# **COUNCIL REPORT**

From: Chris French, Planner I File No: DP 22-10

Subject: DP 22-10; Development Permit with Variance; 1386 Bear Creek Road

**Figure 1:** Landscaping improvements proposed by applicant

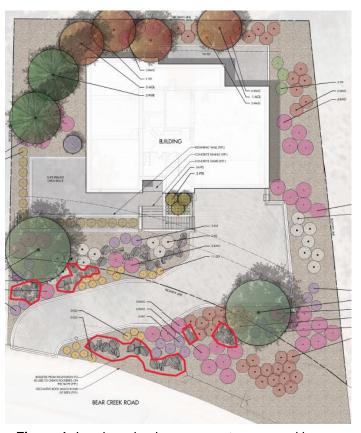
The subject property is designated in the Official Community Plan as a Hillside Development Permit Area. The Hillside Development Permit Area is to ensure that development is safe from hazardous conditions and does not adversely affect the natural environment or surrounding people or property. A geotechnical report was submitted with the application that confirms that the proposed development is feasible provided that recommendations for slope stability are implemented in the design and construction of the home. In addition, a landscaping plan has been submitted for site improvements for which the applicant will be required to submit a performance bond to the City in the amount of \$31,250.00 preliminary cost (125% of the estimate) as a condition of issuance for the Development Permit.

**THAT** issuance of the Hillside Development Permit (DP 22-10) be withheld pending receipt of landscaping security in the amount of \$31,250 for works in accordance with the landscape plan.

**Figure 2:** New height interpretation in Zoning Bylaw No. 0265 for measuring the height of the proposed development at 1386 Bear Creek Road.

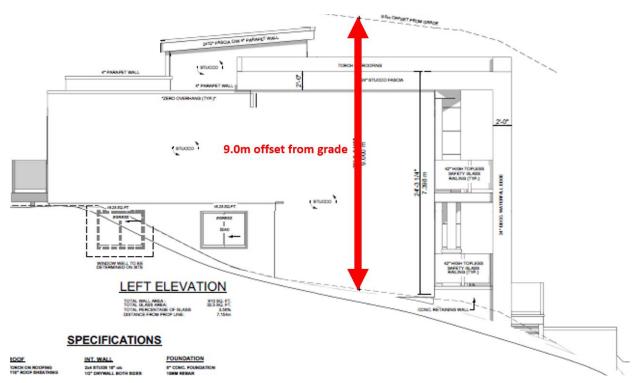
**Section 10.4.6(a)** permits the height of a single building wall face in the R1 zone to be 9.0 m. The applicant has requested a variance to this section of the Bylaw to construct a single-family home with a secondary suite with the front wall of the home being 9.98 m tall. However, the interpretation for height under Zoning Bylaw No. 0154 would incorporate the top parapet wall, which is stepped back in the house design, making the overall front building wall 11.6m.

The permitted height of a single building wall face has been removed from the updated Zoning Bylaw No. 0265 and there is a new permitted height (10m) and interpretation for the height of a dwelling. Staff therefore support this requested variance as the proposed development is in accordance with the height regulations of Zoning Bylaw No. 0265. The overall height of the dwelling would be taken from grade and setback 1.5 metres from the side as shown in the illustration below.

**Figure 3:** Driveway contour the driveway requiring a variance to Section 4.3.4(b)

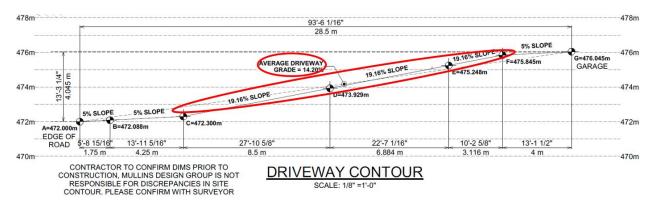
**Section 4.3.4(b)** permits a maximum permitted slope of 12.0% for any parking and loading areas in Single Detached Residential zones. The average grade of the driveway

for the proposed development is 14.2% but is up to 19.16% in some areas as shown in Figure 2. The applicant has requested this variance due to overall challenges with the slope and to ensure that the driveway is routed through a "Driveway Zone" prescribed by a covenant on the property. The covenant was registered at the time that this parcel was created through subdivision to ensure that adequate sightlines were provided for vehicles entering and leaving the property from Bear Creek Road.

Staff support the requested variance as no concerns were raised from the Fire Department or Engineering Department during the development review process. The fire department confirmed that, in the event of a fire, an apparatus would be expected to park on the street. The distance from where the apparatus would park to the home is sufficient to address any fire emergency. The Engineering Department also confirmed that no issues would be expected for other emergency vehicles to access the property.
